With reference to his application dated 4th October 1912.
 Mr. Abdullah Ali Khan is informed
 that the plan submitted by him for building a house
 on plot No. 21 Survey Sheet 23
 situate in Quila Street Amber
 Quarter, is approved, and permission to build in accordance therewith is
 granted. The building to be erected subject to the Byelaws and Rules of the
 Municipality.

I beg to inform you that I intend building a house
on plot No. 51Survey Sheet No. E.3. Situate in _____
Street Pun Chare Quarter. _____As required by the rules of the Municipality, I beg to submit herewith
a plan of the same for your approval.

The plan showing the 1st floor to be built
on plot No. 51.E.3. Panchore Quarter.
Scale 10 feet to 1 inch.

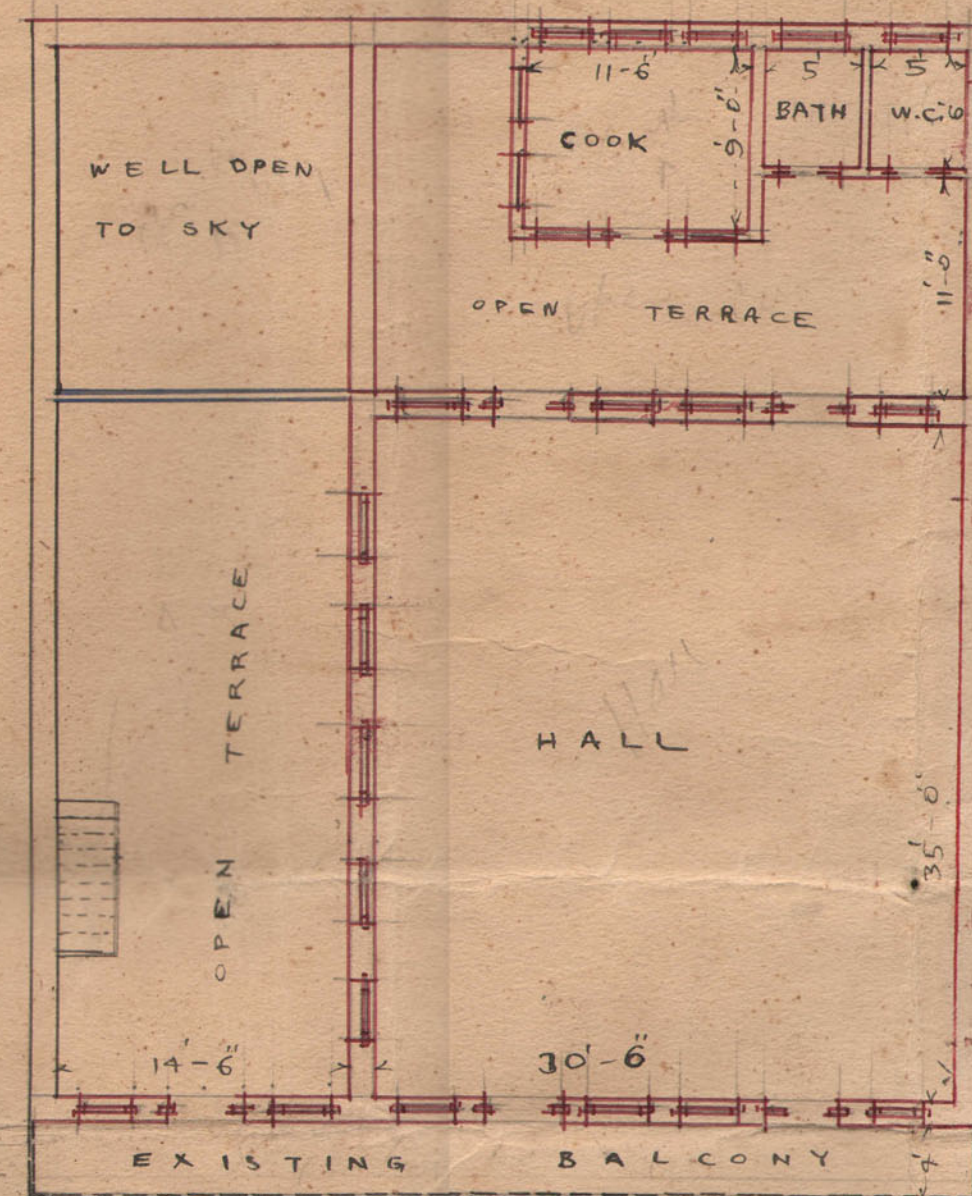
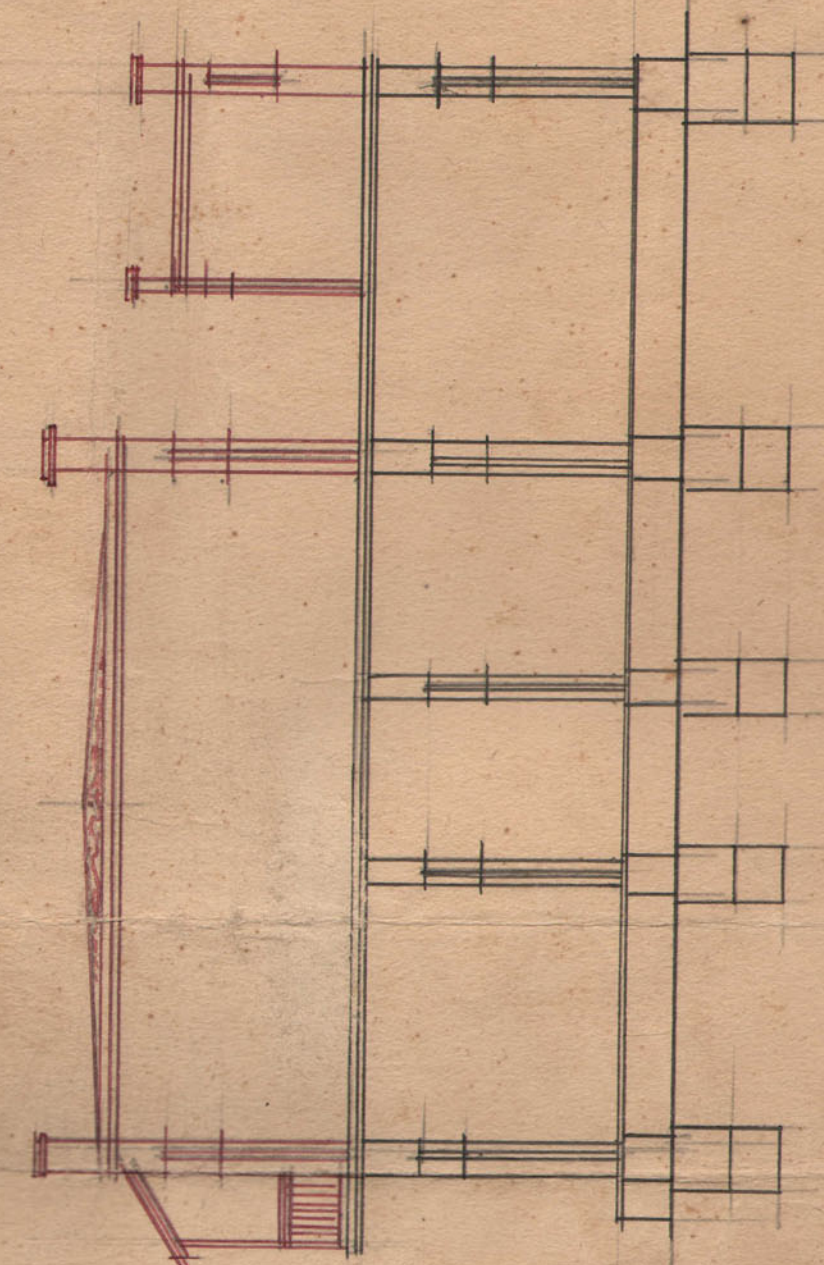
In continuation of this office No.E.6309 dated 29/30th October 1912, Mr. Abdul Hussein Alibhai owner of plot No.51, E-3, Runchore quarter is informed, the windows as shown on the east side of the plot open on Municipal ground which cannot be allowed and the position of the water closets and bath must be altered as required by the Byelaws.

The plan is returned for amendment.

With reference to your memo No.
E 6309 dated 30th October 1912 I beg to
forward herewith the revised plan
with new doors & water closets altered
as required by the Municipality.
